Access Compliance Report

Public Rights-of-Way

(Curb Ramps)

Intersection ID: 10019678	Main Street: ANDOVER_RD	Cross Street: N/A	Location: NE
ADA ID: 84C5BF280B83	Ramp Type: Perp	Initial Pass/Fail: Fail	Overall Compliance: No
			Severity Score: 35

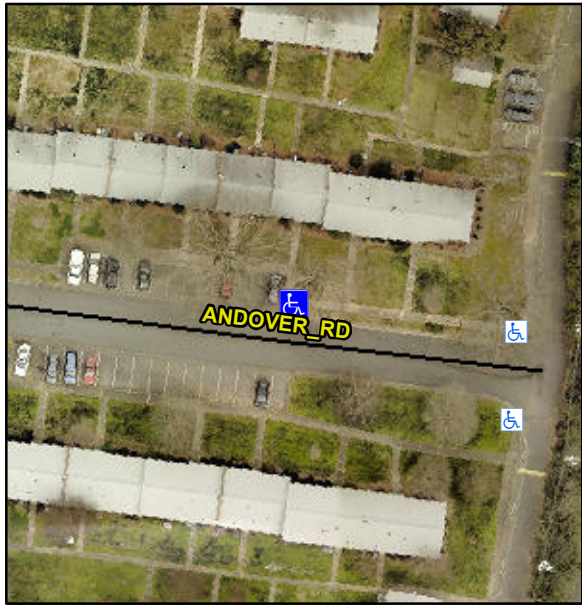
Codes/Mitigation Info/Possible Solution			Field Measurements/Component Compliance					
	Possible Solutions:		Compliance	Description	Data	Compliance	Description	Data
	Remove & Replace Entire Ramp.		N/A	Ramp Length (in)	48.0	No	Ramp Slope (%)	16.2
			No	Ramp Width (in)	36.0	Yes	Ramp XSlope (%)	2.3
			N/A	Flare Type LT	N/A	N/A	Flare Type RT	N/A
			N/A	Flare Slope LT (%)	N/A	N/A	Flare Slope RT (%)	N/A
			N/A	Flare Traversable LT?	N/A	N/A	Flare Traversable RT?	N/A
			N/A	Landing Length (in)	N/A	N/A	DWS Provided?	N/A
			N/A	Landing Width (in)	N/A	N/A	DWS Contrast?	N/A
			N/A	Landing Slope (%)	N/A	N/A	DWS Length (in)	N/A
			N/A	Landing X Slope (%)	N/A	N/A	DWS Full Width?	N/A
Surveyor Notes:	N/A		N/A	Landing Curb? (Y/N)	N/A	N/A	DWS Offset (in)	N/A
			N/A	Shared Landing?	N/A			
	PROW/ADA:		N/A	Gutter Ponding?	N/A	N/A	Gutter Slope (%)	N/A
	R304.5.1, R304.2.2		N/A	Gutter Lip Ht (in)	N/A	N/A	Gutter X Slope (%)	N/A

N/A	Painted X Walk1?	No	N/A	Painted X Walk2?	N/A
				X Walk 1 Direction	To SW		X Walk 2 Direction	N/A
			N/A	X Walk 1 Width (in)	N/A	N/A	X Walk 2 Width (in)	N/A
				X Walk 1 Slope (%)	0.6		X Walk 2 Slope (%)	N/A
				X Walk 1 X Slope (%)	3.4		X Walk 2 X Slope (%)	N/A
			N/A	Ramp inside XWalk1?	N/A	N/A	Ramp inside XWalk2?	N/A
			Road Slope (%)	N/A	N/A	Clear Space?	N/A	
			Road X Slope (%)	N/A	N/A	Clear Space to XWalk (in)	N/A	
		N/A	Any Obstructions?	N/A	N/A	Storm Grate/Utility Hazard?	N/A	
			Obstruction Type			Storm Grate/Utility Type		
					N/A		N/A	
						Yes	Surface Condition? (G/P)	Good
